From: Scala, Mary Joy
Sent: Tuesday, April 28, 2015 10:47 AM
To: 'markwgreen@gmail.com'
Cc: 'Jeff Bushman'
Subject: BAR Action- 608 preston Avenue- April 2015

BAR 15-02-04
608 Preston Ave
Tax Parcel 320014000
King Lumber Partners, LLC, Owners/ Mark Green, Applicant
Revisions to renovation plan

**CITY OF CHARLOTTESVILLE
BOARD OF ARCHITECTURAL REVIEW
STAFF REPORT
April 21, 2015**

BAR 15-04-05
608 Preston Avenue
Tax Parcel 320014000
King Lumber Partners, LLC, Owners/ Mark Green, Applicant
Revisions to renovation plan

PROJECT
FIRST FLOOR PLAN - ENTRY CORE

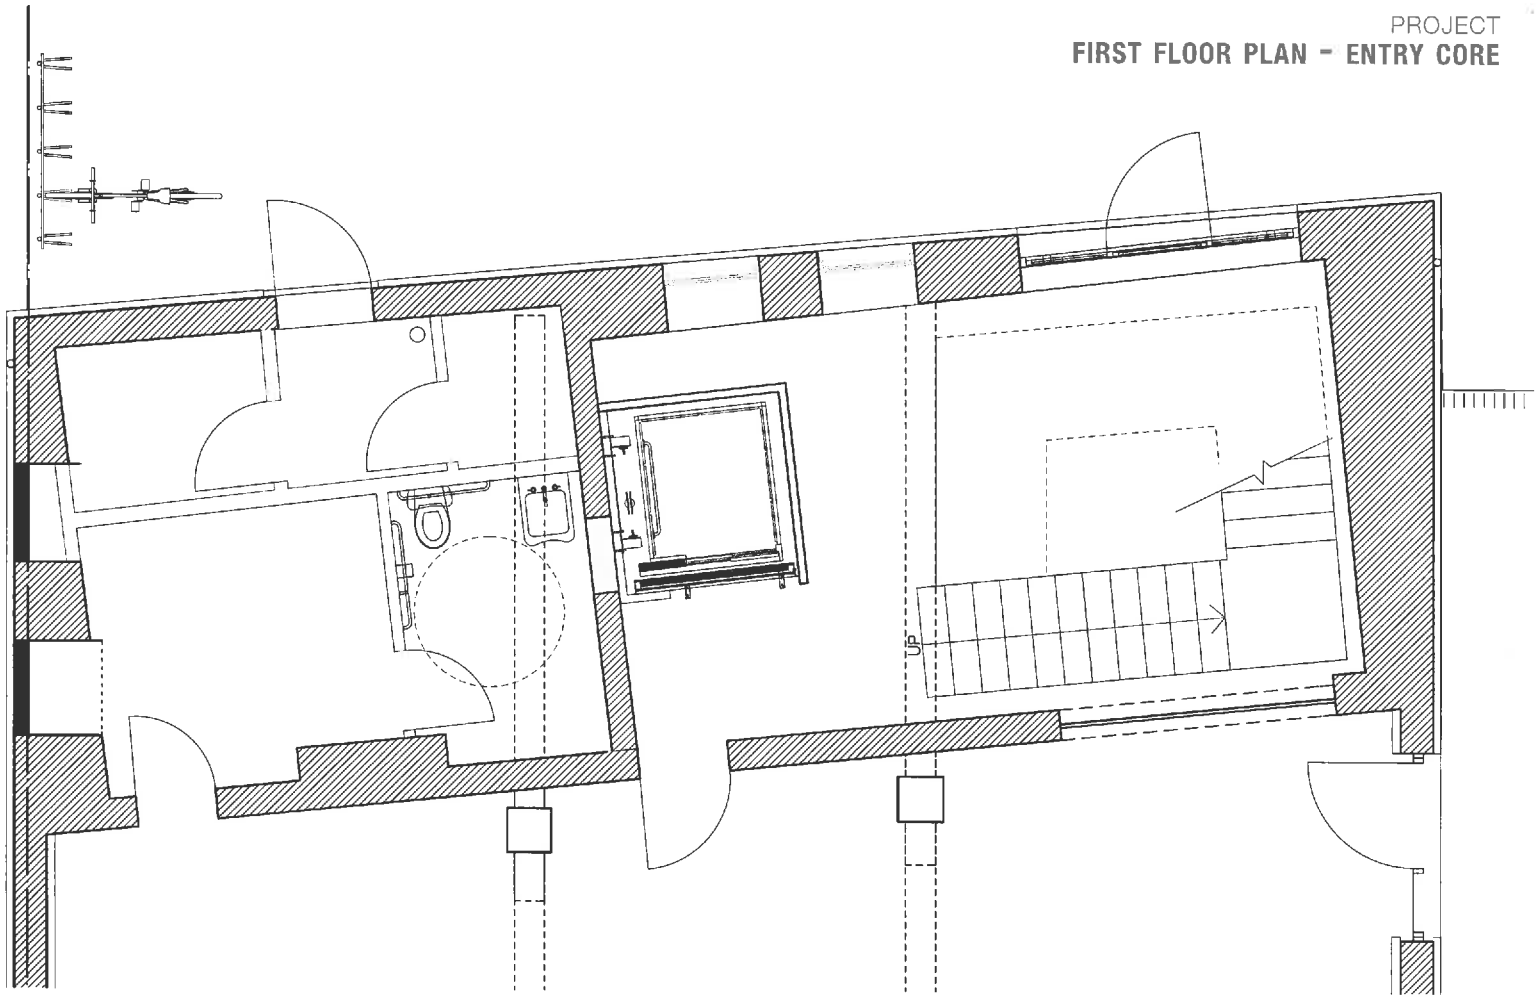
Re: the stair and new arched opening on the south.

Re: the stair handrail

There is plenty of room for the door. Please refer to the attached diagram.

We didn't take Kurt's suggestion as a mandate, thought "it would look really neat" if we support the inner handrail from the stair instead of the brick wall.

We have not detailed the handrail and guardrail yet, but we did pull the structural channel 3" away from the wall, a detail confirmed by our structural engineer this morning.

Supporting the inside handrail with simple vertical posts welded to the top of the channel would be easy to accomplish, and our intention is to go in the direction Kurt suggested.

NORTH ELEVATION
SCALE: 3/32" = 1'-0"

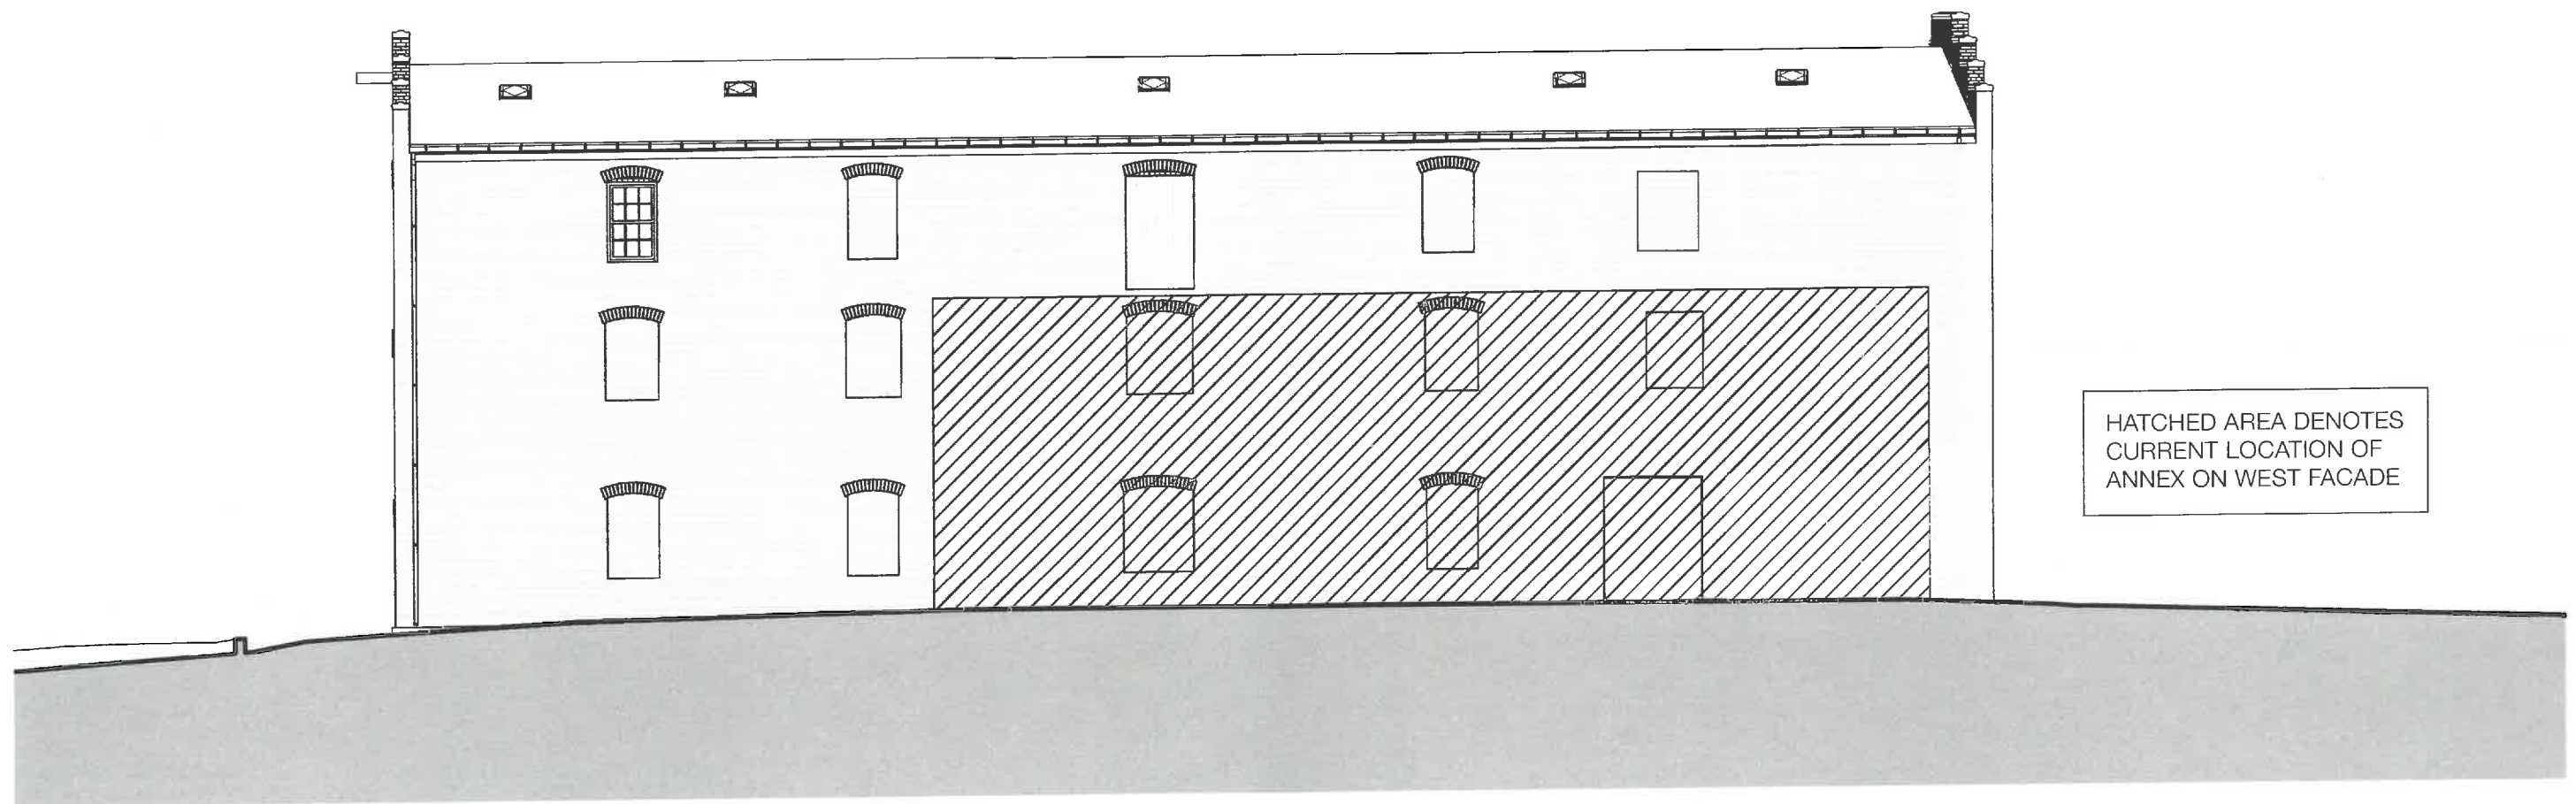
Re: the windows on the north

Our intention is to go with arched top center windows on the north elevation - unchanged from our previous submission.

You caught us in the middle of some decision-making - we were having trouble finding glass big enough to use so we took a look at a square-top window, matching the shape of the old doors that used to fill these openings.

But the arch is more elegant and that's our proposal.

SOUTH ELEVATION
SCALE: 3/32" = 1'-0"

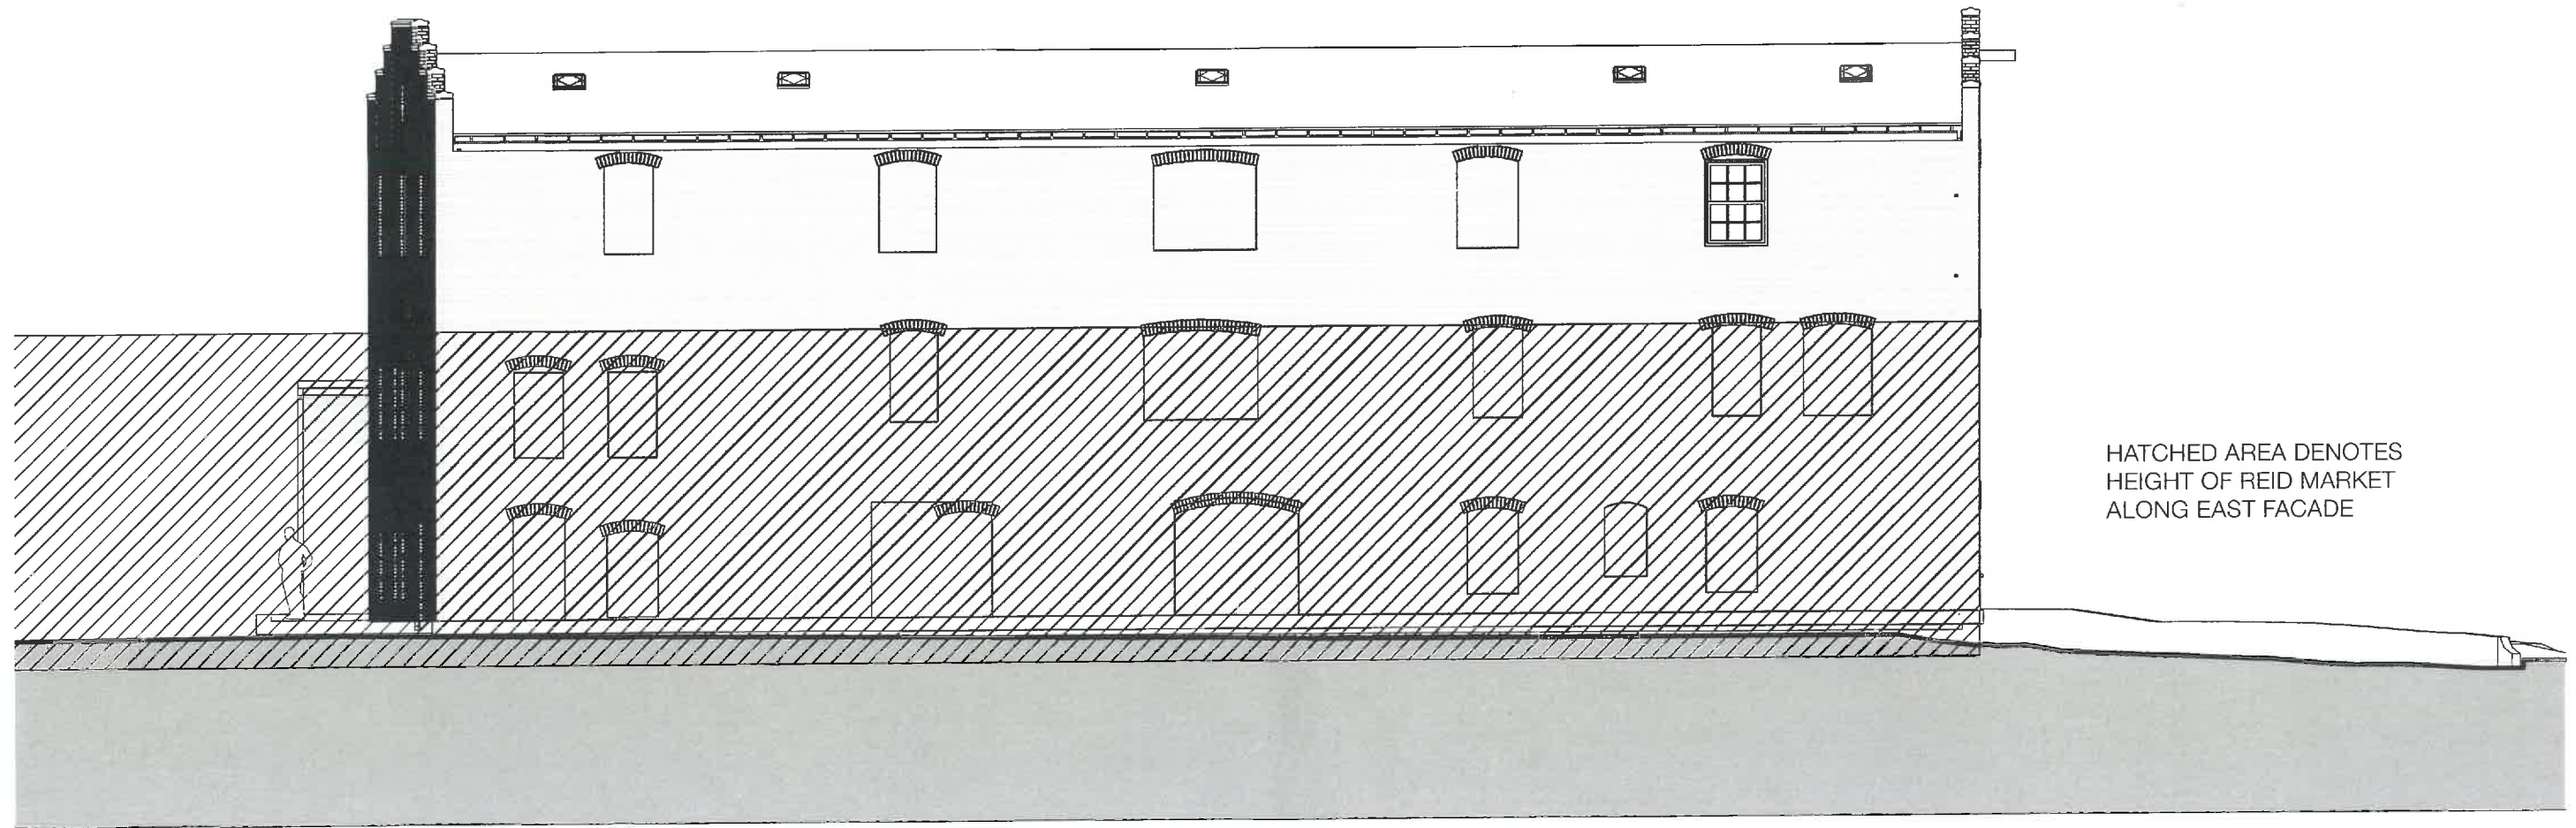
- The new tower and bridge elements have been eliminated. The stair and elevator will be moved to the interior of the building.
- On the rear elevation a previous brick arch opening will be restored as a glazed entry door.
